**Re: RCRA 3013 Administrative Order IND 005 462 601  
Response to USEPA Comments Dated April 28, 2015  
Additional Site Investigation Report for the Former Coke Plant  
Tecumseh Redevelopment, Inc., East Chicago, Indiana**

Benzene Iso-Concentrations in Shallow Groundwater – July 2013 (Figure 14)

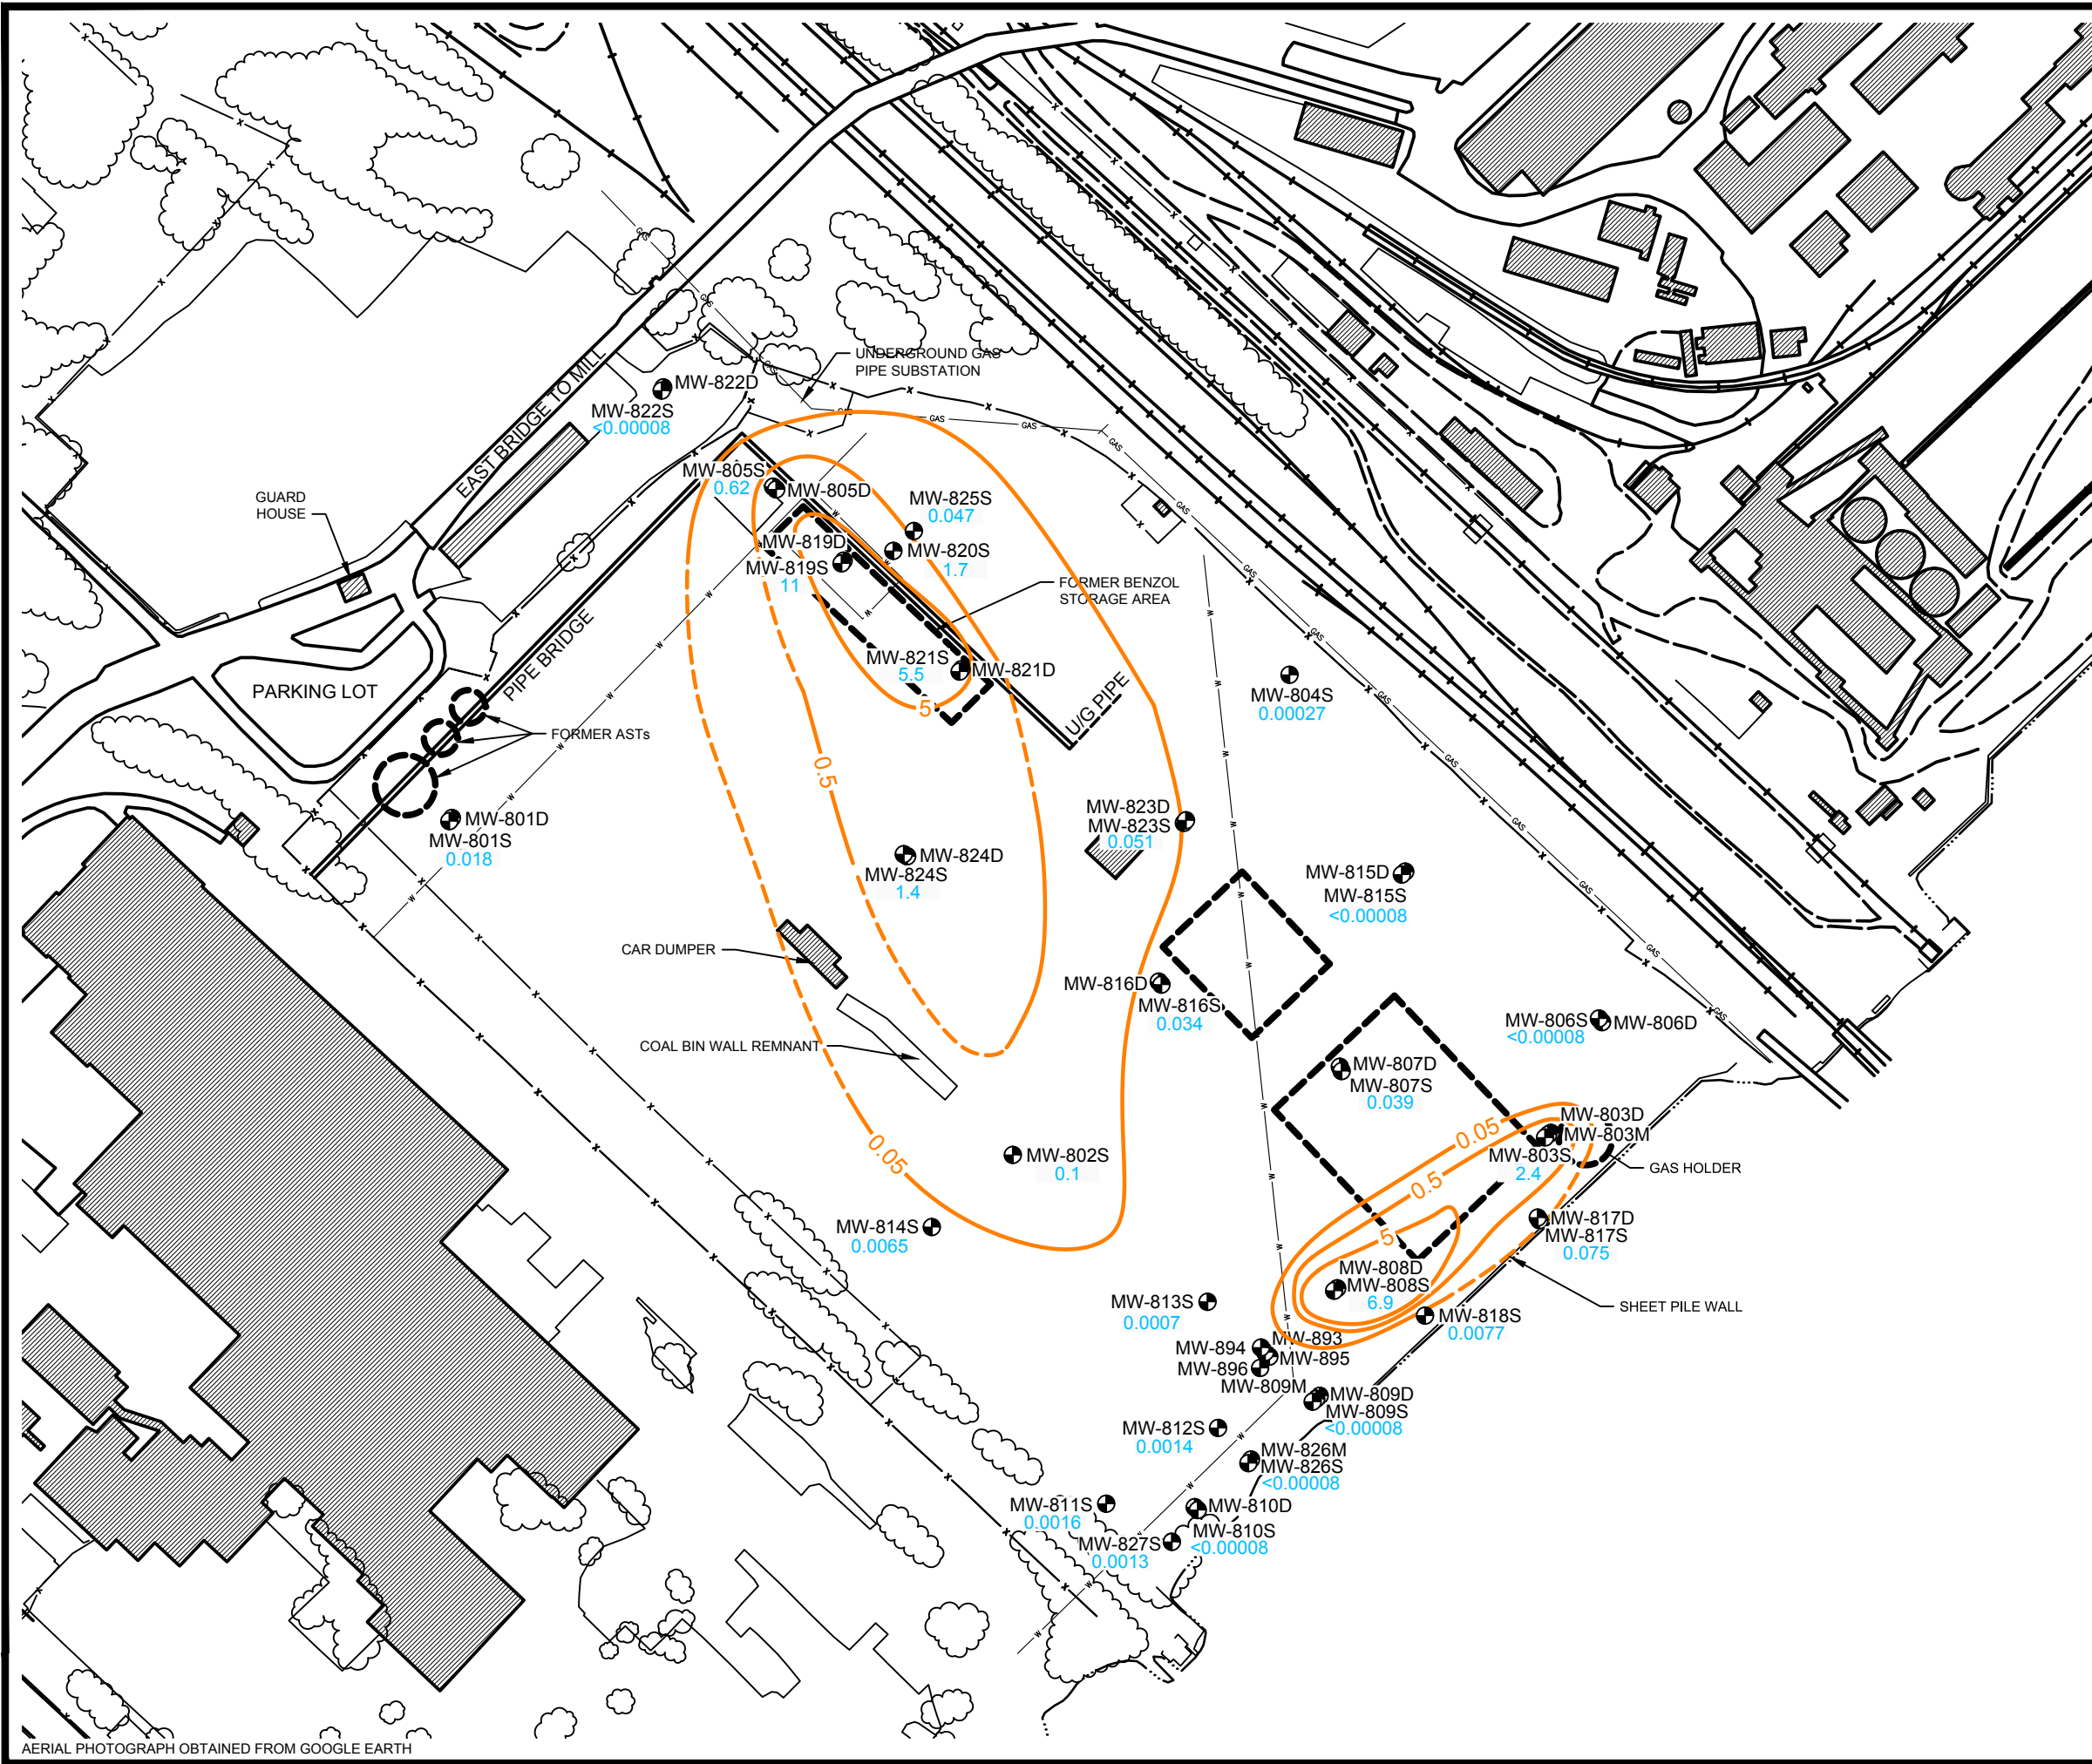
Although the figures have been revised to use dashed lines showing the inferred nature of the contaminant footprint, there is still uncertainty with regard to the extent of exceedances west of well MW-819S/D and south of well MW-824S/D. Dashed lines should also be used to project the contaminant footprint in groundwater in these areas.

***Response: The enclosed revised Figure 14 includes a dashed 0.5 mg/L benzene contour west of well MW-819S/D and south of well MW-824S/D.***

**Thickness of Clay and Silt  
Overlying Carbonate Bedrock  
Indiana Harbor**

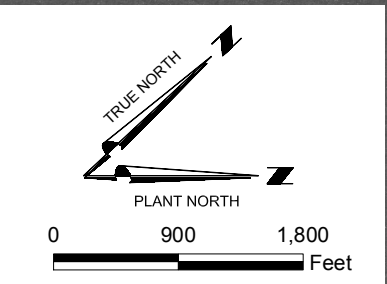
1. In the response, ArcelorMittal indicates that "the clay layer is laterally extensive across the former Coke Plant site." However, just because the clay may be extensive does not mean that it is continuous and, therefore, capable of acting as a hydraulic barrier to contaminant migration. The report must provide additional detail as to whether the clay has been consistently identified in each boring of similar depth at the former Coke Plant site. If an insufficient number of borings has been advanced to this depth, the Pre-Design Investigation should also include steps to confirm and document that the aquitard is continuous across the site.

***Response: The estimated thickness of clay and silt overlying the carbonate bedrock within the vicinity of Indiana Harbor based on lithologic information from 40 soil borings is attached. Based on this information, the thickness of clay and silt overlying the carbonate bedrock near the Former Coke Plant ranges from 80 to 100 feet.***
